Subject: Declaration letter of the similarity

We, Continental Automotive GmbH, hereby declare that for our products below present the same RF, electrical and electromechanics characteristics. There are only slight appearance differences of Clips, Centering pins, Global Shape of the housing, Connector & LightGuide, between the 2 models.

DHS HMC NFC DL3

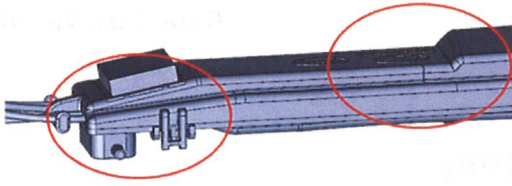
Also, the location of the capacitance is different as below:

DHS HMC NFC DL3 C521/C528 (10pF)

DHS HMC NFC MQ4

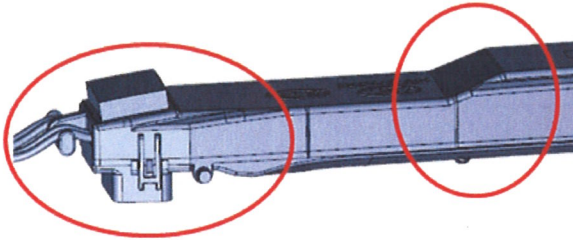
DHS HMC NFC MQ4 C521/C528 (4.7pF)
